**SUBJECT: URBAN DESIGN ADVISORY GROUP COMMENTS TO THE DRAFT
ENVIRONMENTAL IMPACT STATEMENT**

INTERSTATE 5 COLUMBIA RIVER CROSSING

DRAFT -Design Guidance for the Columbia River Crossing Project

Exhibit 3-2. North Portland Harbor Crossing

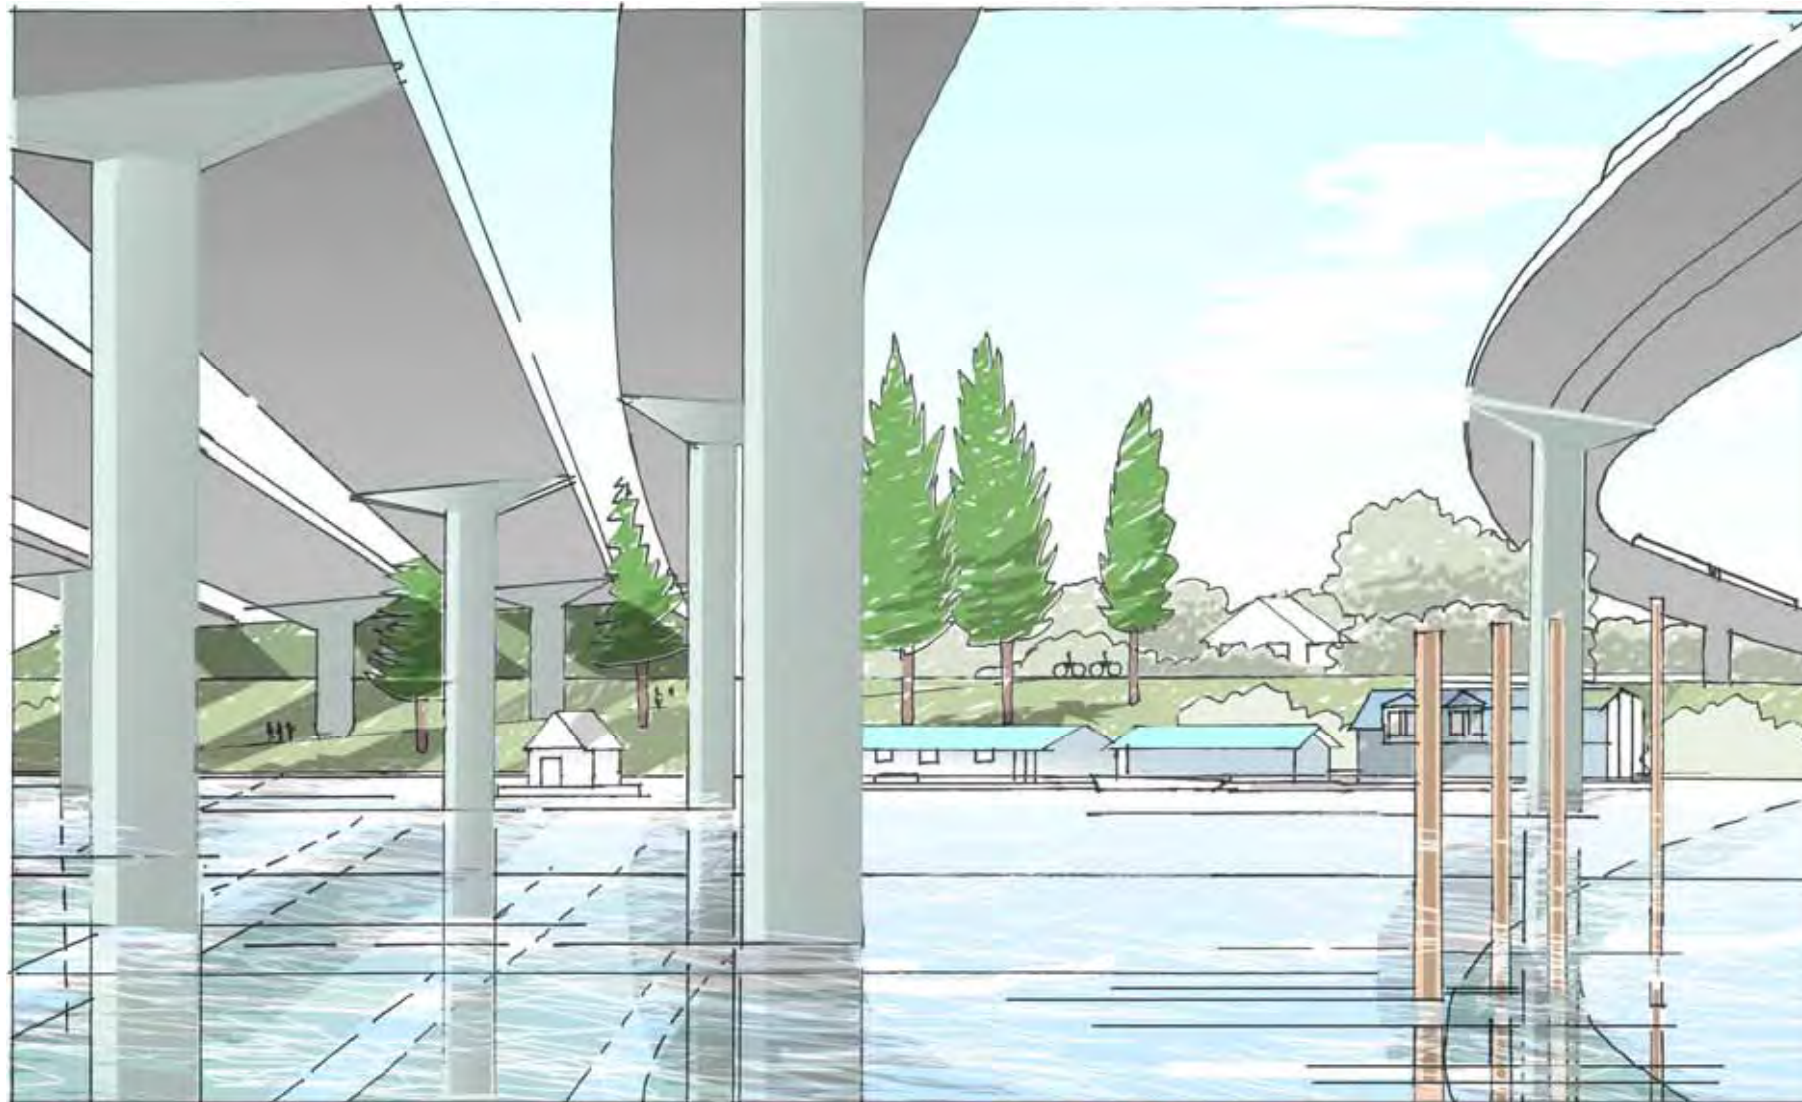
5. Improve pedestrian and bicycle access along the south bank of the North Portland Harbor under the highway with adequate headroom and lighting, thus connecting Bridgeton to the 40-mile loop. Provide safe and convenient access to the Expo transit station. *Improve waterfront trails.*
6. Minimize piers in North Portland Harbor and consider bridge types independent of the constraints that shape the bridge over the Columbia River. *Consider other bridge types with fewer columns in the water.*
7. Construct the highway ramp and transitway spans over the North Portland Harbor as light and elegant bridges. Their architecture need not reflect that of the main highway spans. *Make detached bridges light and elegant.*
8. Preserve highway views towards Mount Hood. *Preserve views to Mt. Hood.*

Exhibit 3-3. Hayden Island LRT Station and I-5 Crossing

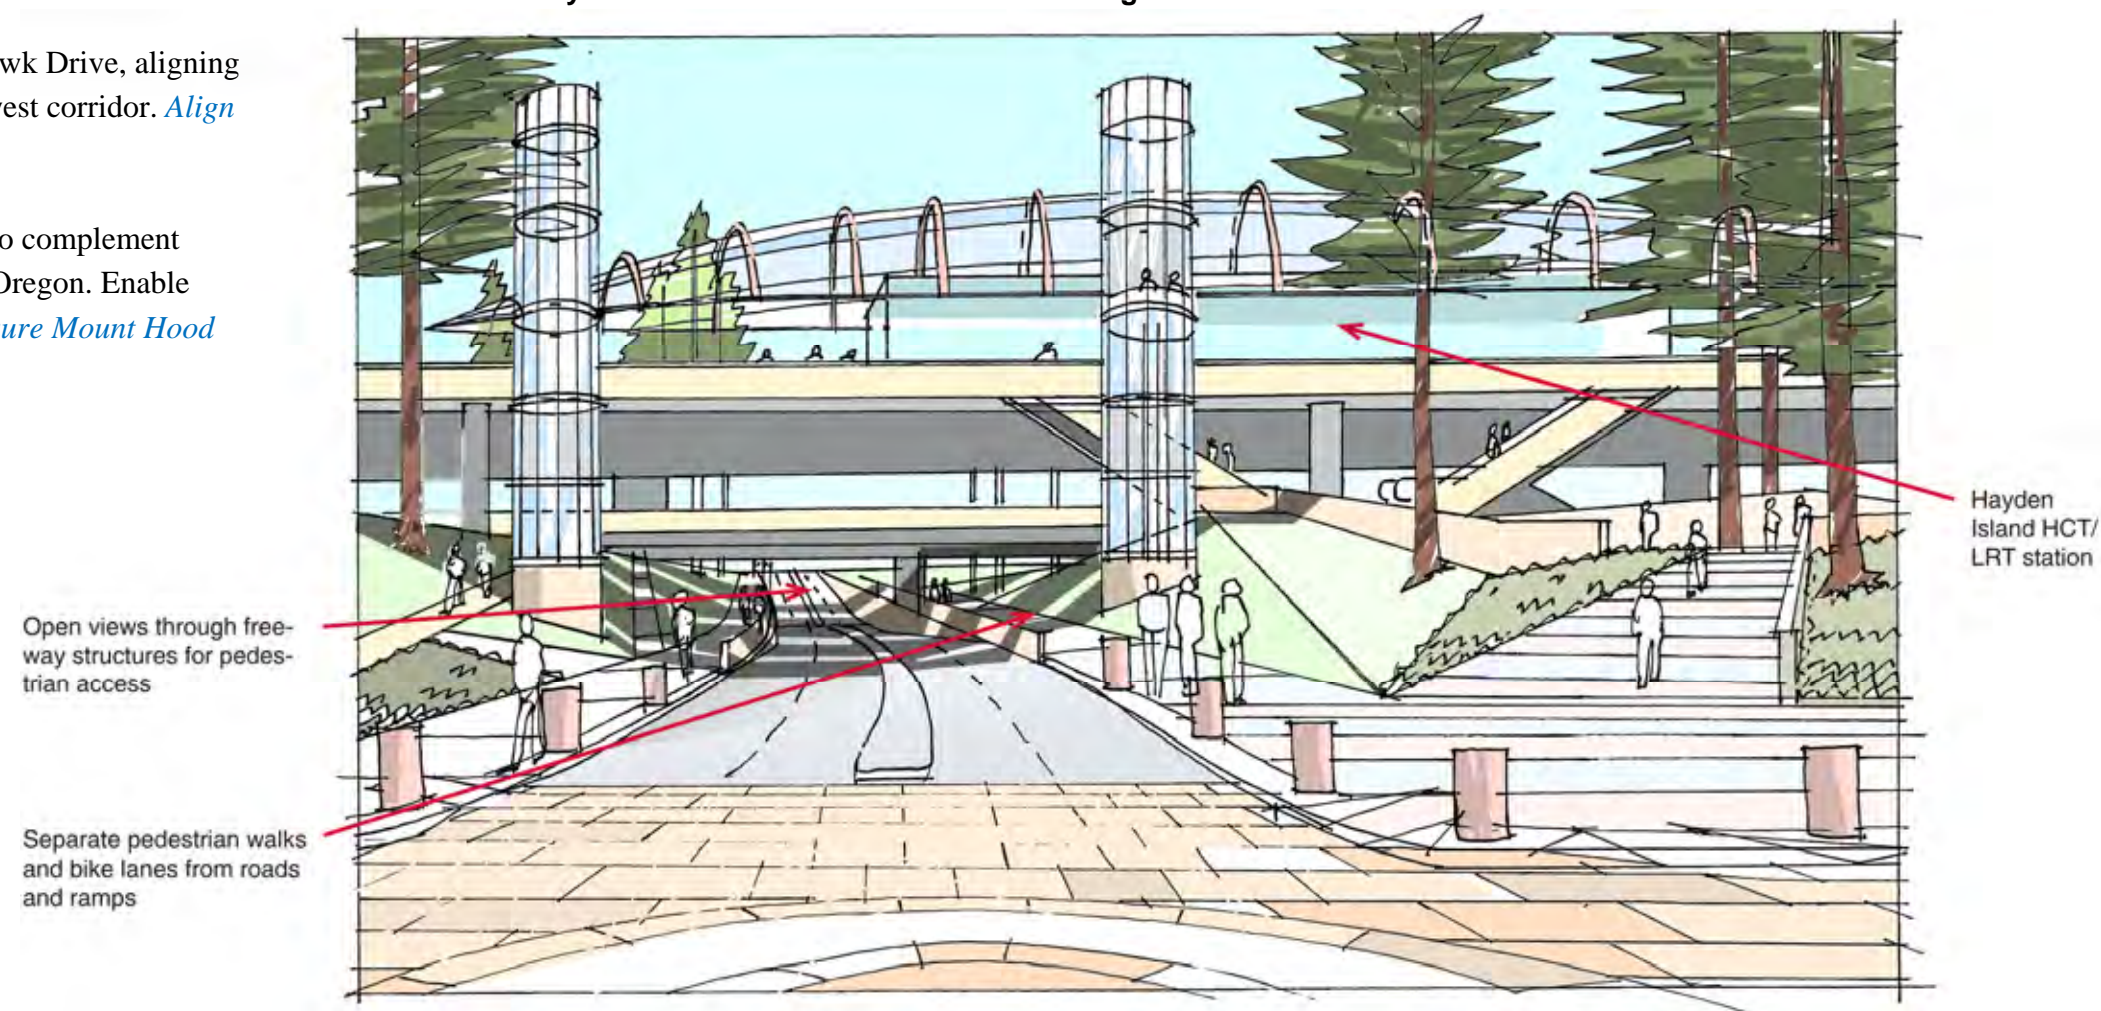
11. Locate the station directly above Tomahawk Drive, aligning access and landscape with the planned east-west corridor. *Align transit station with Tomahawk Drive.*

15. Increase separation between ramps at the Hayden Island interchange to enable creation of generously planted landscaped terraces. Use this landscape also for natural treatment of storm-water runoff. Design noise walls and berms integral with the interchange to reduce noise trespass to the east and west. *Space ramps to admit daylight and generous landscaping.*

Exhibit 3-5. Columbia River Spans

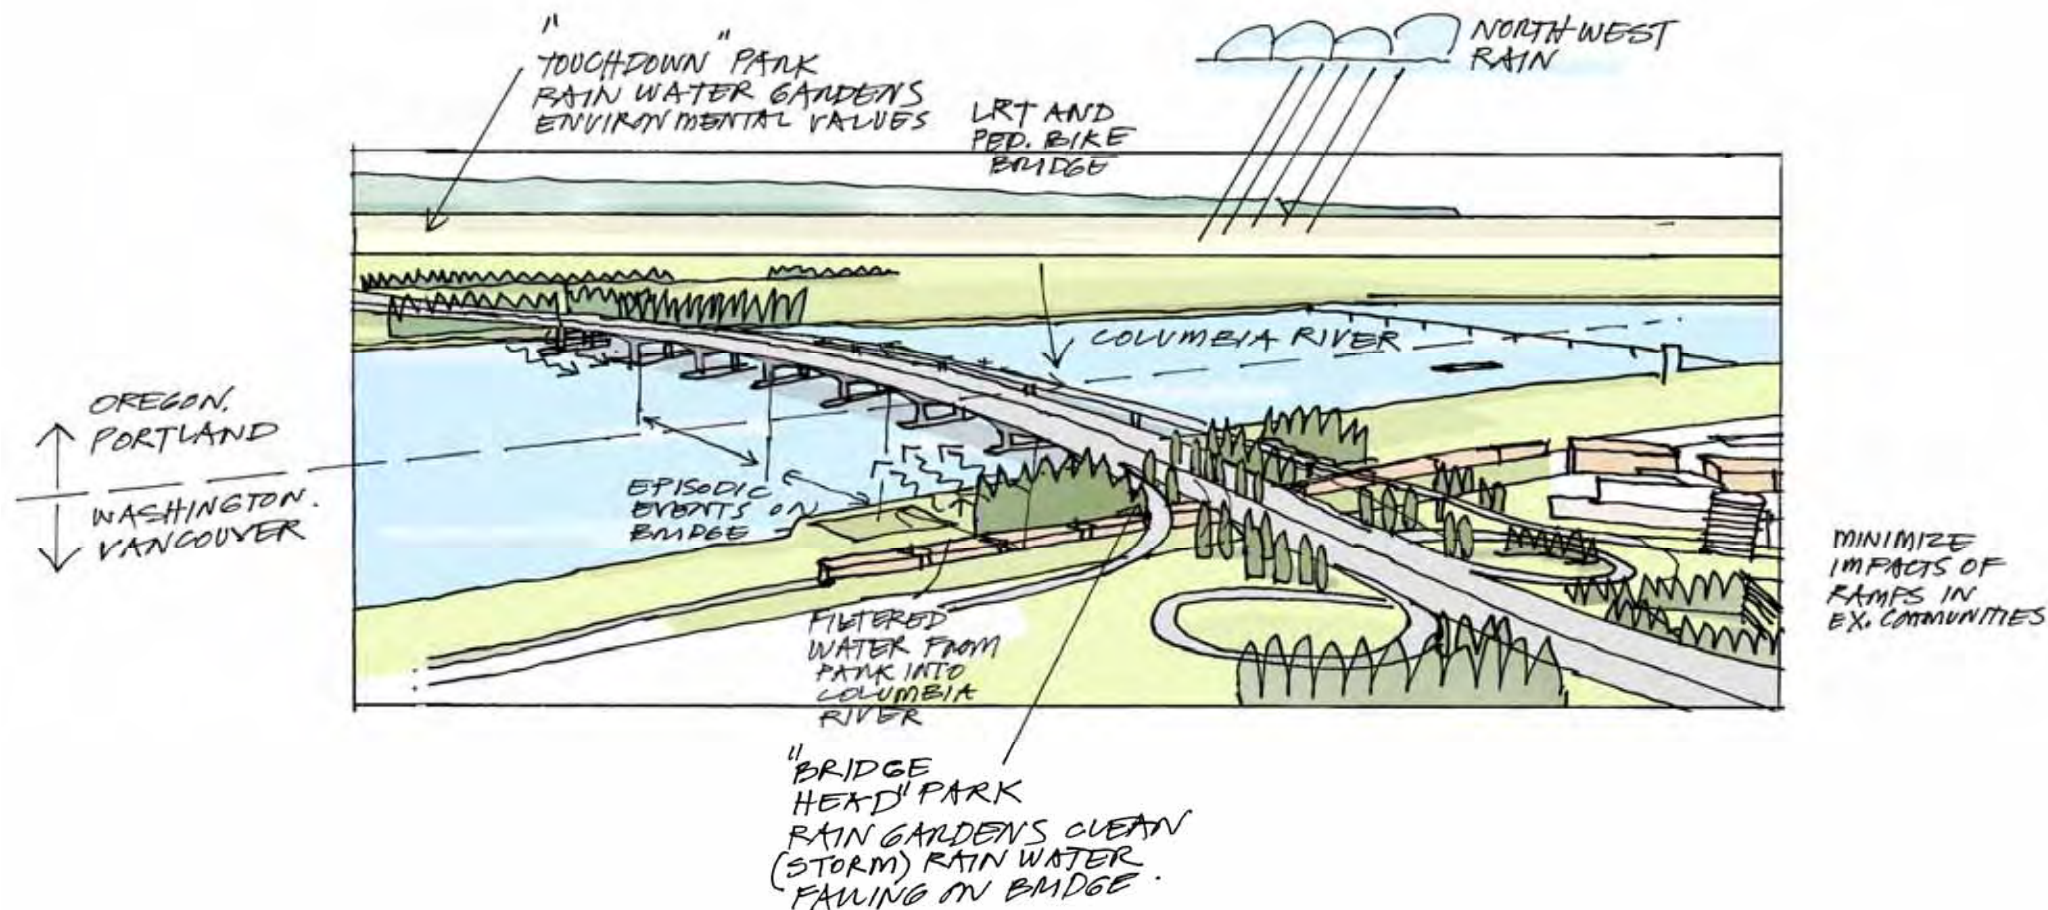
16. Members of the UDAG recommend that the FAA be approached to consider a greater height allowance for the north end of the CRC span, permitting consideration of bridge types other than girder and box-girder. (It has been suggested that an element of interpretation by FAA staff has been involved in setting the imaginary surface height restrictions, and that a different interpretation might change the limits on bridge type). *Challenge aviation height limits.*

21. Consider design opportunities on the south parts of the span that are relatively unconstrained in height. (FAA height limitations related to Pearson Field have effectively reduced bridge type selection to a single choice: box girder bridge. This might suggest a non-symmetrical bridge design or inclusion of an iconic object associated with the river crossing. Astoria Bridge demonstrates use of two distinct bridge types, one of limited height, the other much higher. Such options do not appear to have been considered for CRC). *Consider other bridge types south of the Pierson Airfield constraints.*

22. Use landscape and controlled views to build anticipation of the river crossing in those approaching the main span. *Design dramatic approaches to the river crossings.*

Exhibit 3-6. North Bank & SR 14 Interchange

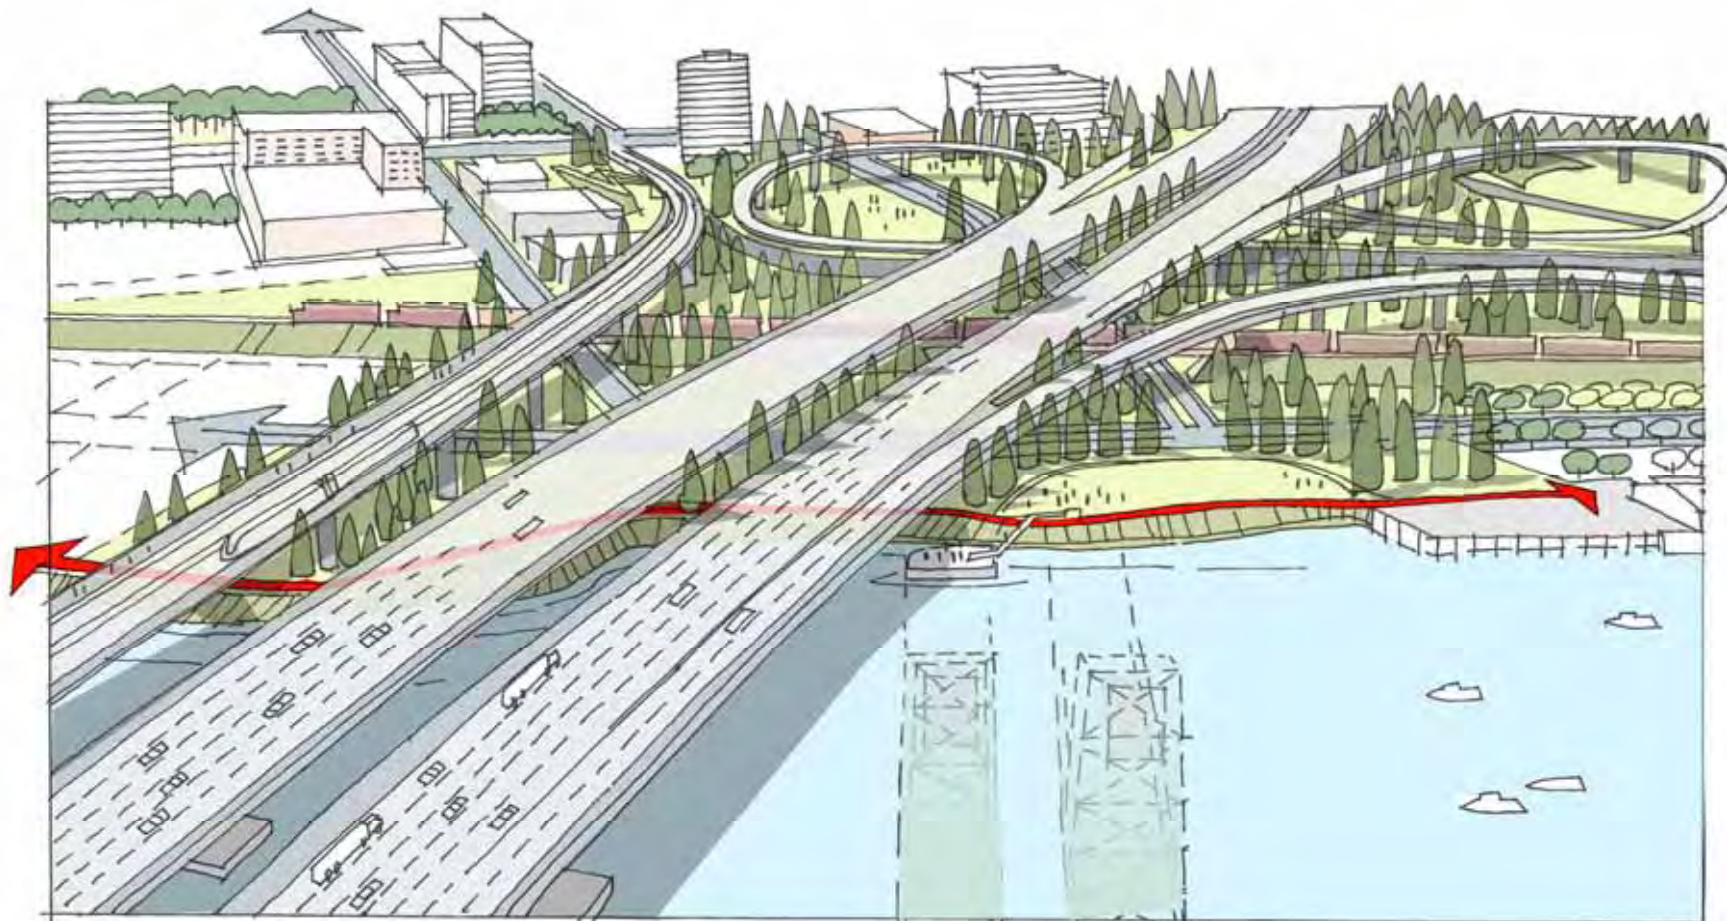
23. Redesign the river bank at the former bridgehead under I-5 and the Red Lion site as urban park space in which people can meet, enjoy views, and otherwise use this shoreline destination. *Reconfigure the under-bridge as destination public open space.*

24. Investigate options for regrading and redesign of the river bank under the highway, including options for retention of fragments of the old bridges. *Investigate different under-bridge designs*

25. Designate a continuation of the regional trail through this space. *Include continuation of the waterfront trail.*

Exhibit 3-8. Seventh Street Footbridge

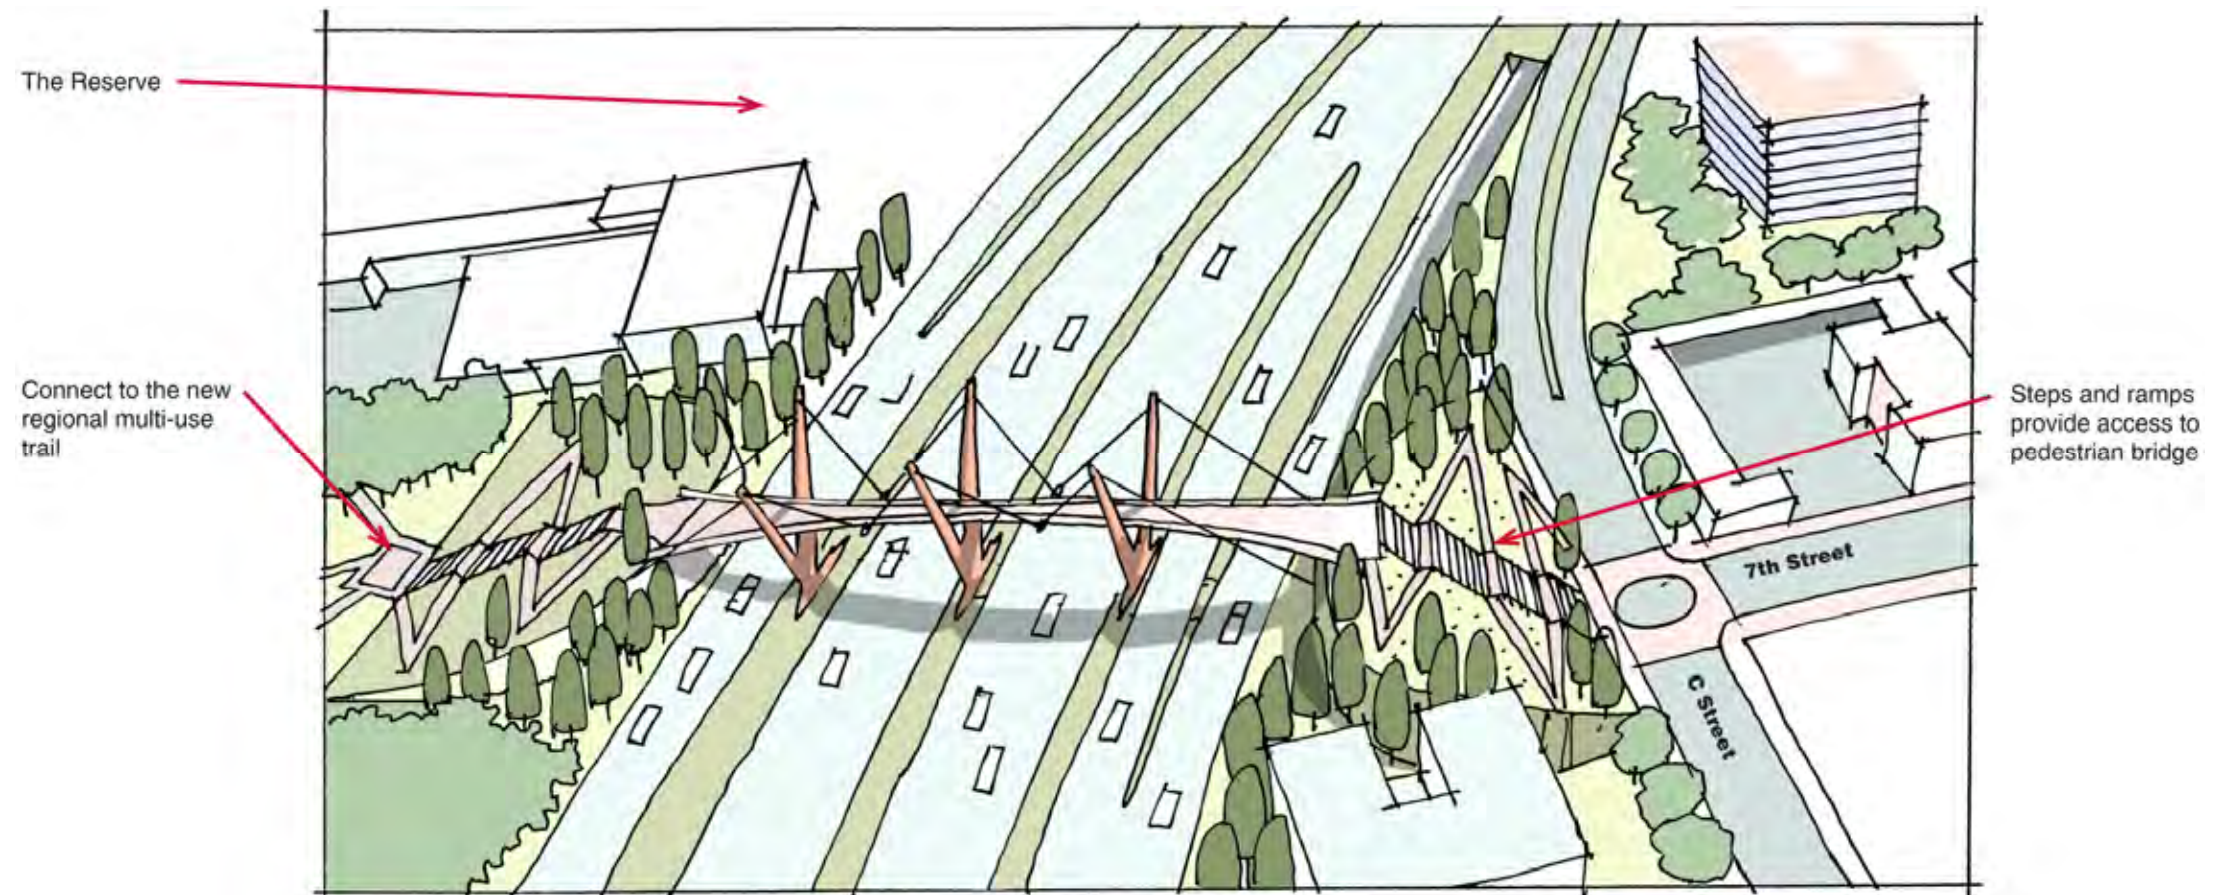
34. Consider the design of the 7th Street footbridge as an opportunity to announce approach to the bridge with an elegant and colorful structure. *Make the footbridge a colorful gateway.*

35. All of the Downtown highway crossings should be addressed functionally and visually as an integrated system. *Consider the collective appearance and function of Downtown crossings.*
